Re: Northern California Power Agency Lodi Energy Center (08-AFC-10C)
Revised Petition to Amend Air Quality Conditions of Certification

**Petition to Amend
Air Quality Conditions of
Certification for the
Lodi Energy Center Project
(08-AFC-10C)**

**Petition to Amend Air Quality Conditions of Certification
for the Lodi Energy Center Project**

CO Emissions During Gas Turbine Startups NCPA Lodi Energy Center

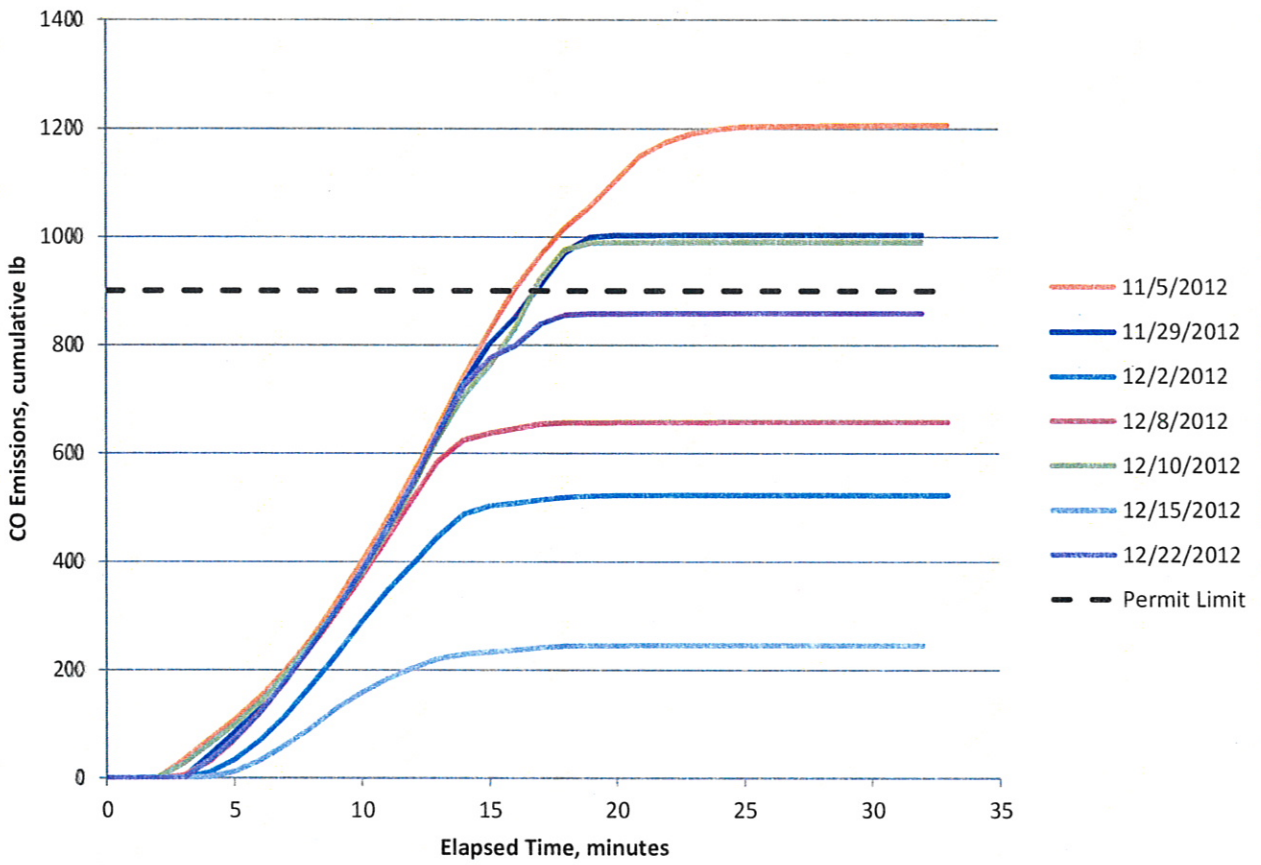
The attached figure shows how CO emissions from the turbine vary during startups. The highest hourly CO emission rate observed during any gas turbine startup to date is 1,207 pounds per hour. Based on this, we are requesting an increase in the maximum hourly CO emissions limit during startup to 1,500 pounds per hour, to provide a 25% compliance margin above the maximum observed emission rate.
